Technical Note TN14034 Issue 1.0

**Upper Gungate PBA TA Review
Staffordshire**

Technical Note 14034
Issue 1.0

Figure 1: Start – End Green Times AM Sensitivity Cumulative, PBA Transyt Model

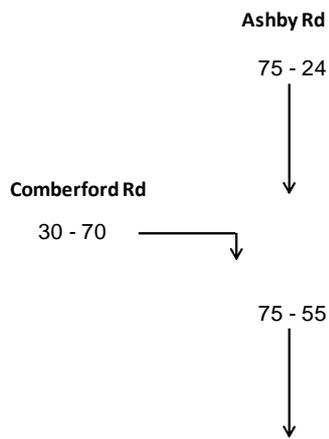
As described in the PBA Transport Assessment Addendum, paragraph 6.2.6, the signal timings were set so that a red signal for traffic at the pedestrian crossing stopline would only be presented to right-turning vehicles from Comberford Road, with the intention of offering good progression for the ahead traffic from Ashby Road. **Figure 1** highlights the timings from the PBA Transyt model for the AM Sensitivity Cumulative scenario.

Referring to the timings shown in Figure 1:

The traffic leaving the Comberford Road stopline takes approximately 4 seconds to arrive at the stopline downstream. Therefore, any traffic crossing the Comberford Road stop line from time 30 (start of green) to time 51 (21 seconds into green) should pass through the downstream stopline during a green signal. However, any traffic crossing from time 51 to time 70 (end of green) will encounter a red signal at the crossing. Drivers arriving from Comberford Road are turning a corner and may not expect to encounter another signal, those arriving just after 21 seconds may therefore not be attentive to the red signal at the second set of signals and may fail to stop. The right turn from Comberford Road is relatively high, 510 pcus, and if traffic demand at the end of any cycle remains high, this has the potential to stop a large number of vehicles at the next stopline (up to 10 pcus per cycle). Queues will potentially block back to the stop line at Comberford Road. This is also likely to have an impact on Ashby Road. Although the signals at Ashby Road begin the green phase at the same time as the phase downstream, there will be a queue in the reservoir ahead due to the traffic that was stopped from Comberford Road. As this does not disappear as soon as the signals go green, the traffic from Ashby Road will be impeded by this queue for a short period once released from the first stopline.

The PBA Transyt model uses the Cell Transmission Model (CTM) in an attempt to replicate queues blocking back to upstream stoplines. The results for the AM Sensitivity Cumulative scenario indicate that a queue of 7.4 pcus will form at the stopline at the pedestrian crossing. However, it is important to remember that this is the average cyclic queue, and could be higher during periods within the peak demand is higher.

JCT consider that including the pedestrian crossing within the same stage stream as the signal junction, and maintaining suitable clear out periods, will offer increased safety by reducing the risk of red running.

Figure 3: Start – End Green Times AM Sensitivity Cumulative, PBA Transyt Model

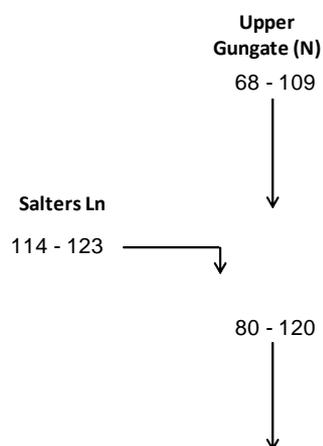
Phase labelling in the PBA modelling does not match those within the original JCT modelling. Phase delays in the PBA model are significantly different, to those in the JCT models. **Figure 3** illustrates the green timings for the AM Do Something Cumulative scenarios that will result from the PBA phase delays, and the impact these will have on southbound progression.

The cruise times between the stop lines at Salters Lane and Upper Gungate (N) to the stopline downstream are short (about 3-4 seconds). Therefore, the majority of traffic leaving Salters Lane each cycle will be stopped at the stopline downstream. The ahead traffic from Upper Gungate is then provided with a green signal 12 seconds before the downstream green signal. This traffic will join the back of the queue, and will result in blocking back to the upstream stopline, and result in underutilised green time. The timings in the JCT model were set up so that the southbound traffic from Upper Gungate (N) would not be delayed at the next stopline.

Although the modelling attempts to take into account blocking back using the Transyt Cell Transmission Model (CTM), Traffic Stream 3A, Lane 2 has incorrectly been set up to use the Congested Platoon Dispersion Model (CPDM) Model rather than CTM. As a result, the model does not model any blocking back to the upstream stopline. This was clarified by TRL, who stated “CPDM will not model blocking back effects if TRANSYT does not identify it as a flare” and “CTM needs to be chosen for both traffic streams on both Arms 2Ax and 3A”.
